My Ref: KAB/
22/B/01

Date:
06/04/22

HIGHWAY REPORT

The Redevelopment of Former Chambers Bus Depot Church Square Bures St Mary Suffolk CO8 5AB

Extract of proposed access and minor works.

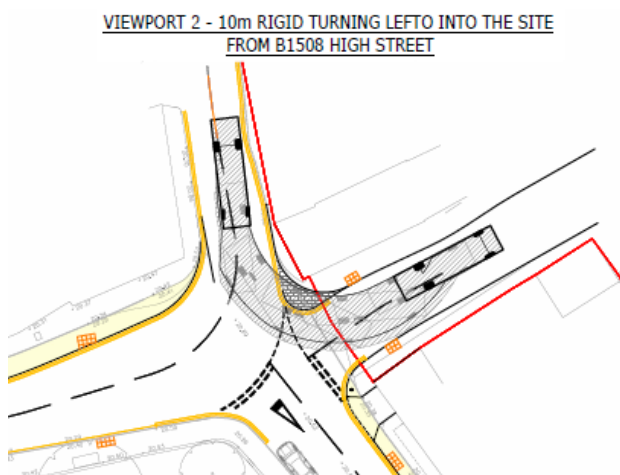
2.09 ACE has submitted a series of hgv turning geometry plans relating to a 10m rigid delivery vehicle, and a standard residential refuse vehicle. These are useful in explaining the dangerous manoeuvring difficulties likely to be experienced by the drivers of such vehicles visiting the site. NB – it is not clear why ACE has not chosen an articulated hgv as the “design vehicle”, as it seems likely that such a sized hgv will deliver to the site.

2.10 It is noted that the Road Safety Audit (RSA) gives no consideration to these hgv turning geometries, even though the RSA guidance GG119 for Stage 1 RSA's says..

Similarly, the CHA does not appear to have considered these serious issues. Indeed the RSA and CHA assessments appear to be lacking in other important highway safety considerations as set out in GG119 for Stage 1 RSA's, and as forming any standard Highways development Management assessment of a development proposal e.g.

2.14 It might be argued that the number of hgv movements will be relatively low. However, it is clear that all these hgv movements will produce such fundamentally dangerous, unexpected and hazardous conflicts with vehicles using the highways adjacent to the site that even smaller numbers than these will produce unacceptable adverse highway safety conditions. Indeed, it may well be that these are illegal movements, being an offence. This is a matter for the CHA to consider. In all cases, the hgv driver and all other drivers exiting the site, have to view, consider, and assess multiple potential vehicle approaching movements, plus potential cyclist movements, and pedestrian crossing movements at each prescribed “uncontrolled crossing” (see drawing at page 9 above).

2.15 As regards pedestrian movements at these uncontrolled crossings across the B1508 and Church Square (i.e. each dealing with a proportion of the total daily pedestrian flow of some 1450 peds per day), it is noted that the RSA raised pertinent highway safety problems about these and proposed pedestrian crossing locations e.g. the RSA said...

2.16 Furthermore, the proposed B1508 pedestrian crossing point is located at a wide section of carriageway, where, even with the proposed footway widening, pedestrians still have to walk more than 8m to cross the road. This puts them in conflict with approaching vehicles for significant period of time, particularly so for mothers walking with children and/or using a pushchair, and elderly or disabled customers.

a)

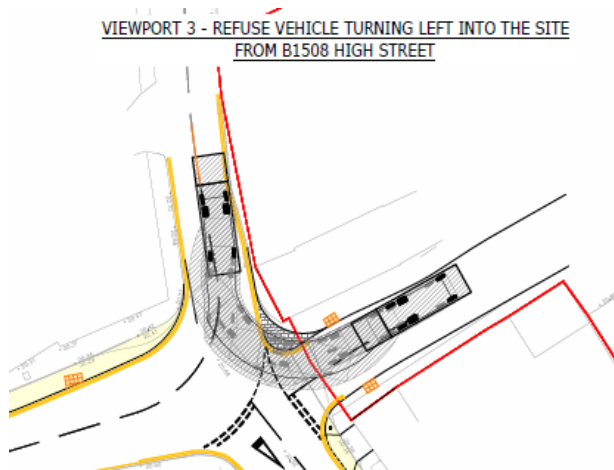
The entering hgv has to cross the centreline of the High Street on the blind bend, into the opposing northbound traffic stream. The entering hgv also takes up the whole of the entry road width, crossing the centreline of the access road, into the opposing (exiting) traffic stream, and where crossing southbound pedestrians are unlikely to have adequate visibility of the approaching hgv, and where it is unlikely that the hgv driver will have adequate sight of crossing pedestrians. In both cases, the hgv driver may be forced to come to a standstill in the major road, or across the major road, or in the access road, due to the opposing vehicles.

b)

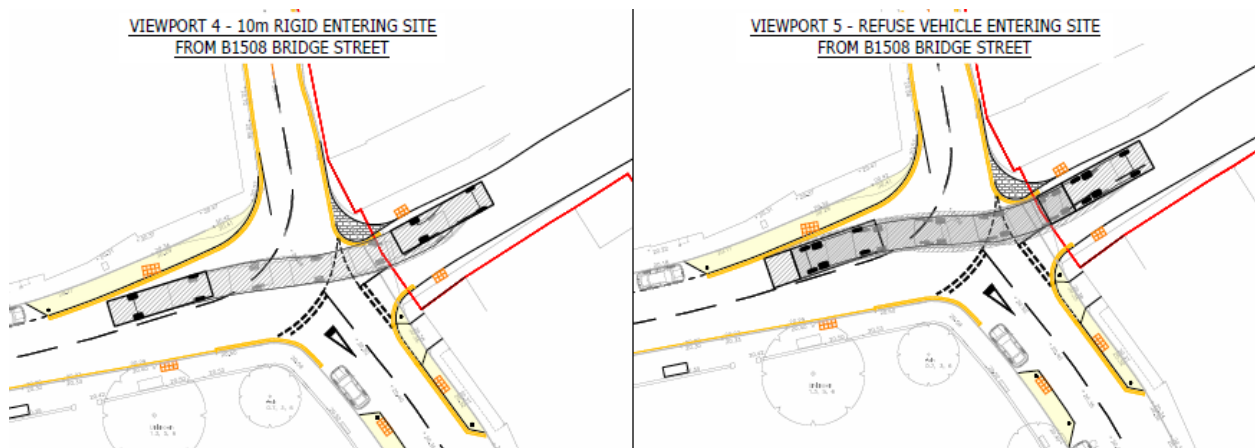
The entering refuse vehicle has to significantly cross the centreline of High Street on blind bend, blocking the whole lane of the opposing northbound traffic stream. The entering hgv has to cross the centreline of the access road, into the opposing (exiting) traffic stream, and where crossing southbound pedestrians are unlikely to have adequate visibility of the approaching hgv , and where it is unlikely that the hgv driver will have adequate sight of crossing pedestrians. In both cases, the hgv driver may be forced to come to a standstill in the major road, or across the major road, or in the access road, due to the opposing vehicles.

c)

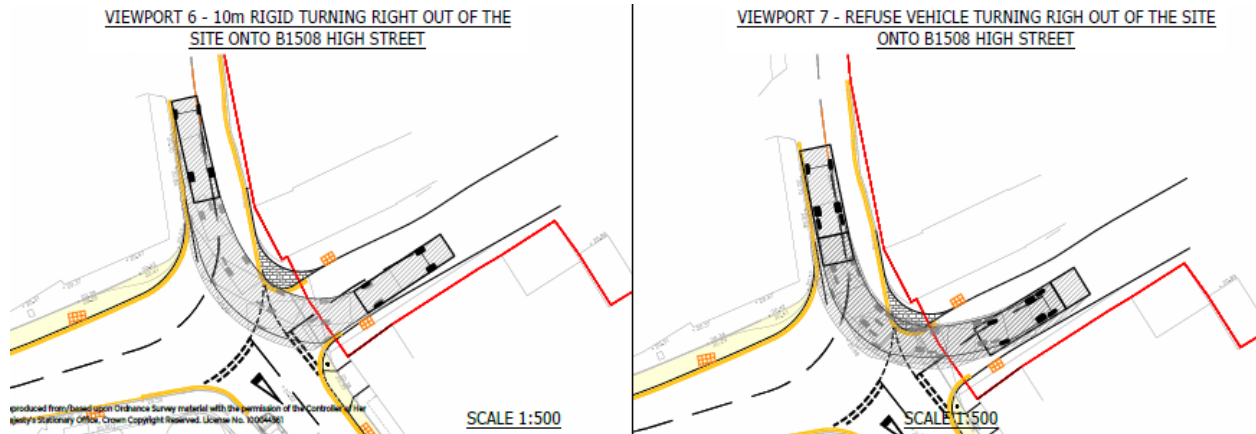
The 10m hgv/refuse vehicle driver is unlikely to have adequate visibility of an approaching southbound major road vehicle, at the point at which he has to commit to driving forward to cross the southbound traffic stream on the shown necessary alignment to enter the access. If he creeps forward to maximise his visibility of southbound approaching vehicles, then these turning diagrams do not reflect that practical manoeuvring situation. In both cases the hgv movement conflicts with left turning vehicles into Church Square, and into the site.

d)

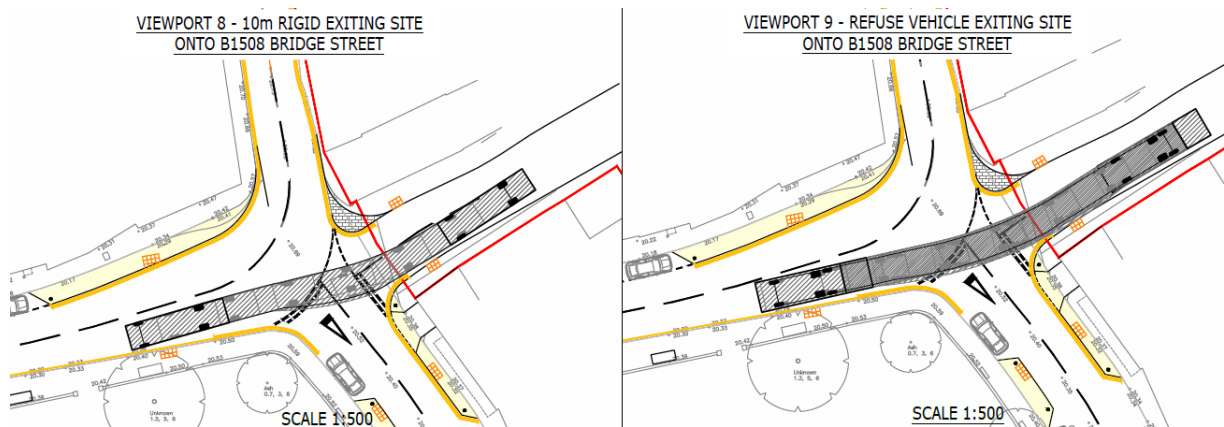
In both the above cases, the exiting hgv has to cross into the entry route of any left turning vehicle entering the proposed development and entering Church Square. As the hgv driver has to commit to this movement within the access road, not at the Give Way line, and, at some distance from the junction with Church Square, it is unlikely that any southbound left turning entering driver will have adequate warning of such a movement and will meet the exiting hgv head-on. Furthermore, at the point where the hgv driver crosses into the entry lane, he will not have an adequate view of southbound vehicles on the B1508. Similarly, any light vehicle driver entering the site, turning right from the B1508, will be unlikely to expect such an unusual movement and will have to brake to a sudden halt when the hgv blocks his entry route. The hgv drivers cannot make any attempt to cross to, and use, the “Give Way” markings at the junction of Church Square with the B1508, as it will not be possible to physically carry out this manoeuvre.

For these hgv movements, the likelihood is that the hgv will have to stop at an oblique angle, at the Give Way markings, and thus straddle the whole of the carriageway of Church Square, blocking access to/from the square.

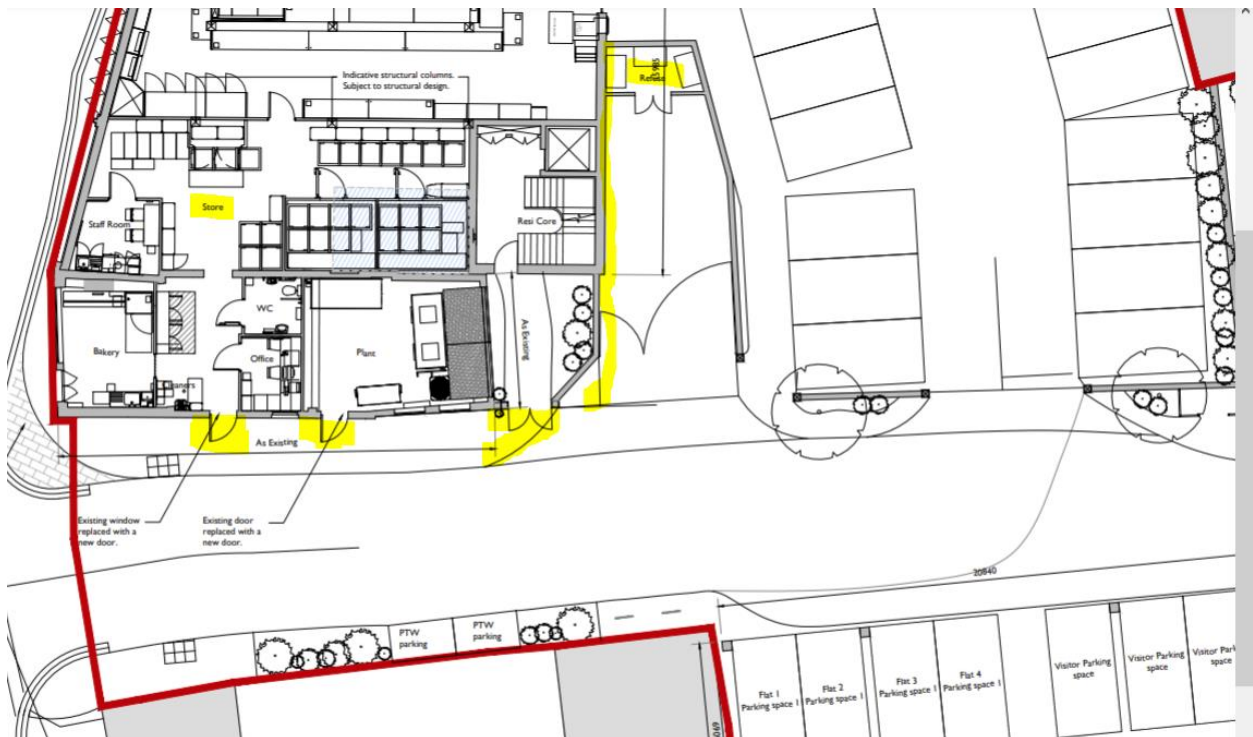
2.22. Similarly, for the right turn entry from Bridge Street into the site access, the light vehicle driver will have to drive obliquely across the junction with Church Square. It seems unlikely that he will be able to signal and make a separate right turn into Church Square, and then signal and make a separate left turn into the site, due to the lack of adequate distance to carry out such a manoeuvre.

2.23 Additionally, there may well be a signalling problem as the driver will be signalling right turn into Church Square but any following driver, turning into Church Square, may not expect the crossing movement into the site access. For the southbound drivers on the B1508, they are unlikely to expect a car to drive across them, but more likely to expect the driver to turn right into Church Square, as the right turn signal would indicate.

2.24 The TA should include the saloon car/lgv turning plans for all the necessary turns to enter and exit the site, so that these potentially dangerous and awkward movements can be properly considered. As indicated above, the level of daily entries and departures related to the convenience store will total some 950 vpd, with pedestrian flows within the same area totalling some 1450 peds/day. Clearly, the potential for vehicle/vehicle conflicts and vehicle/pedestrian conflicts will be high. This will be for every day that the facility is open, and for the period of any planning consent, if that was to be granted.

2.26 Comments as regards the initial length of the access road, as shown below.

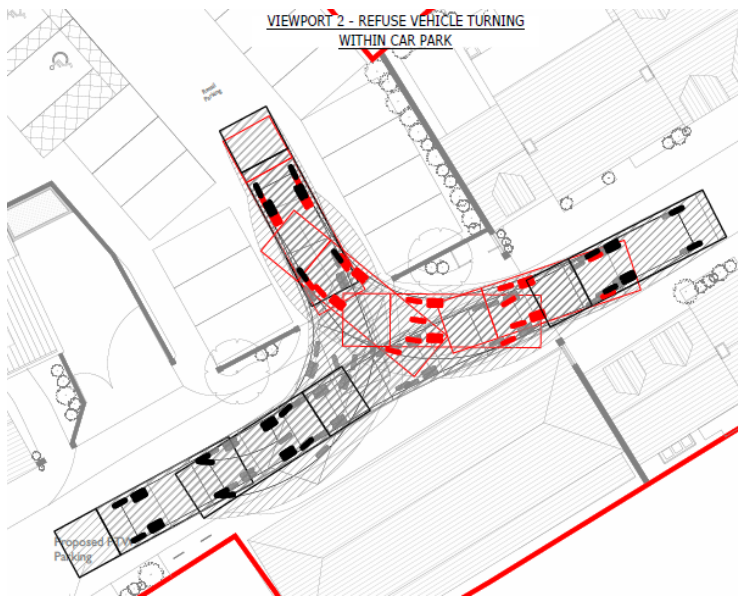
2.27 If it is accepted that the design vehicle for the convenience store must be an articulated hgv, then such a vehicle must sit on the access road carriageway, effectively blocking that route in order to unload. Additionally, the artic will be unlikely to be able to turn within the site. Hence it will have to reverse into, or out of, the site, across the Church Square junction with the busy B1508. Such a movement will produce conflicting and dangerous traffic conditions.

2.28 The TA shows that a 10m rigid hgv can turn within the “delivery area”. However, as shown in the above drawing (2.26) there does not appear to be any connecting route to the goods storage area (see “store” highlighted on the drawing) from the delivery area. This means that deliveries will have to be manually wheeled/carried along the main pedestrian route to the store, thereby conflicting with the entering and exiting pedestrian flows (including mothers with pushchairs, and disabled shoppers etc.). Alternatively (and more likely), the

delivery driver will unload from the more convenient access road position, with easy access to the “store”, but blocking the vehicular access route to the car park and the residential properties, as well as again conflicting with the use of the pedestrian route. Indeed, in such a circumstance the delivery driver may well choose to then turn around within the store car park aisle (the refuse vehicle turning area), as this will be a much easier manoeuvre for him, rather than using the smaller, tighter delivery area. Hence, adding further to the conflicts between hgv’s and customers using the car park. NB – based on the TA TRICS data, the customers using the car park could be some (273.595×4.28) 1172 “vehicle occupants” each day.

2.29 Additionally, the delivery area includes a refuse storage area. It seems unlikely that a commercial refuse vehicle could manoeuvre into this area. Hence, the refuse vehicle will have to park on the access road, blocking the vehicular access route to the store and the residential properties, as well as again conflicting with the use of the pedestrian route. This commercial refuse vehicle will then also turn within the customer car park.

2.31 Furthermore, three sets of access doors open outwards onto the main pedestrian route (highlighted in yellow above at 2.26). This is dangerous and will block the main pedestrian route at the site, thereby conflicting with the pedestrian flows (including mothers with pushchairs, disabled shoppers etc.) to and from the site and possibly forcing pedestrians onto the vehicular access road.

Unacceptable reversing of hgv's in a residential setting – refusal reason 3.

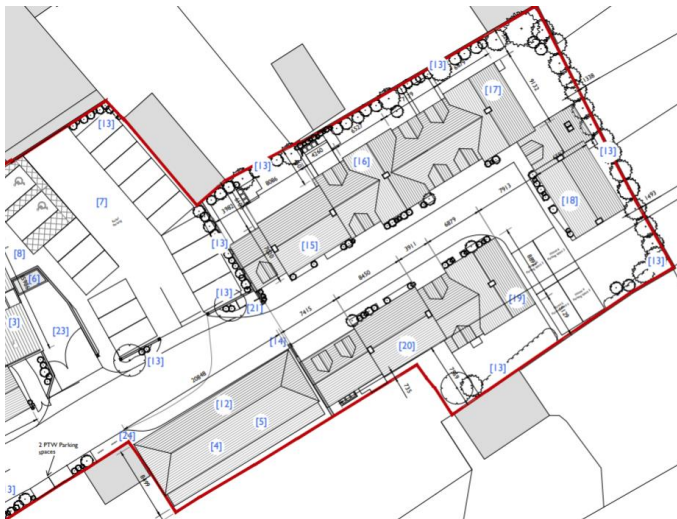
2.34 *The development does not comply with the residential guidance (Manual for Streets and SCC Draft document 2020) for limiting the reversing distances of refuse vehicles and fire tenders with the consequential increased potential for collisions, including pedestrians and cyclists. As regards the latter, this does not comply with the Building Regulations (Requirement B5). Hence any planning consent may not be implementable.*

2.35 Clearly, no refuse vehicle turning area or fire tender turning area has been provided at the residential turning head. The required reversing distance is then some 40m. As already stated above, for refuse vehicles, Manual for Streets, and the SCC emerging residential design guidance warns of the consequences of such situations. This guidance makes clear the dangers of refuse vehicles reversing where members of the public are located (here- moving around the car park area).

2.36 For fire tenders, the Building Regulations requirement is that the maximum reversing distance is 20m. Hence, this proposal does not comply with the Building Regulations (Requirement B5). Therefore, any planning consent may not be implementable.
